EQUIPMENT SERIES: KWM

BULLETIN NO. 2

EQUIPMENT TYPE: KWM-2, KWM-2A

SUBJECT: ADD VOX RELAY TIME CONSTANT CONTROL.

Figure 1. KWM-2/2A VOX Circuit Schematic Changes

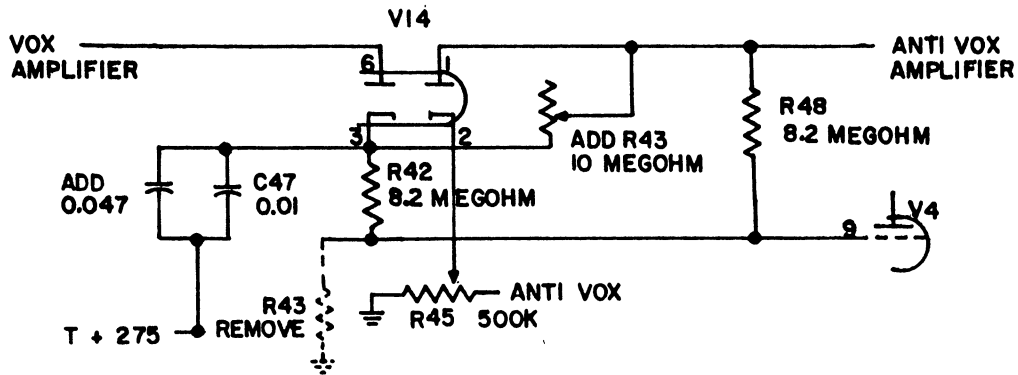
See figure 1 for circuit changes.

1. Remove the feet from cabinet.
2. Lift lid and remove the two unpainted screws from the top rim of the front panel.
3. Slide unit out of cabinet.
4. Remove and discard the 10-megohm resistor R43 located between V4, pin 9 and ground.

Figure 2. Parts Location - Under Chassis

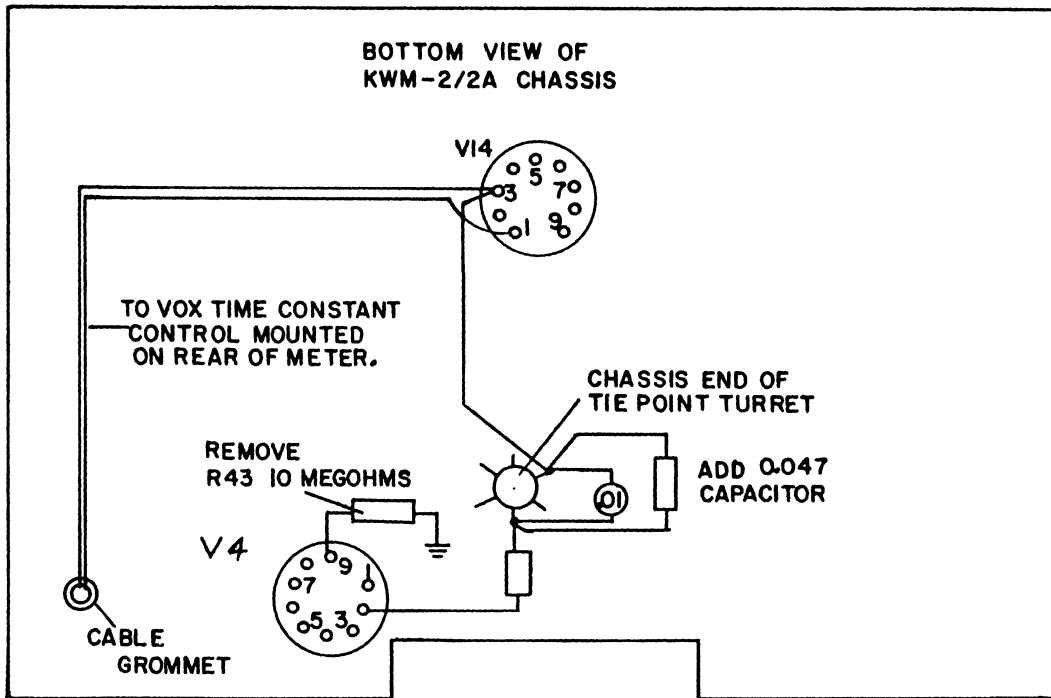
5. Add 0.047-uf capacitor (931-0295-00) in parallel with 0.01-uf disc capacitor located between pins 1 and 3 of E50. E50 is a mounting turret post located between XV4 and XV14 tube sockets. Sleeve leads of new capacitors with insulation (152-1613-00). See figure 2.

Figure 3. Installation of VOX Time Constant Control and Bracket

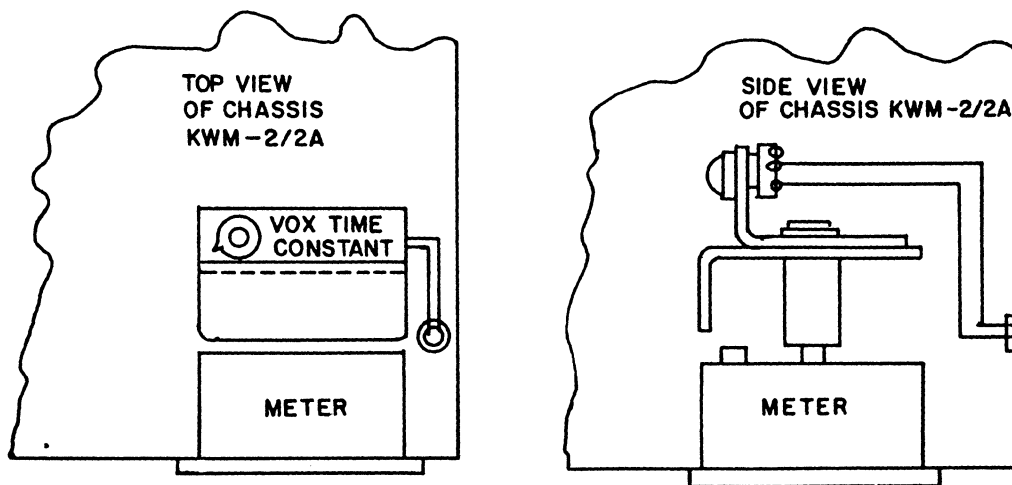
7. With transceiver in upright position, remove the two nuts holding the shield to the back of the meter.
8. Mount VOX TIME CONSTANT control bracket (546-7971-00) on the meter shield using hardware removed in step 7. See figure 3.

9. Solder either one of the 18-inch wires to the center terminal of the control.
10. Solder the other wire to the counterclockwise terminal (as viewed from the shaft end) of the control. Refer to figure 3.
11. Mount VOX TIME CONSTANT control (376-7206-00) in the new bracket, using hardware and knob included in kit.
12. Reassemble unit.
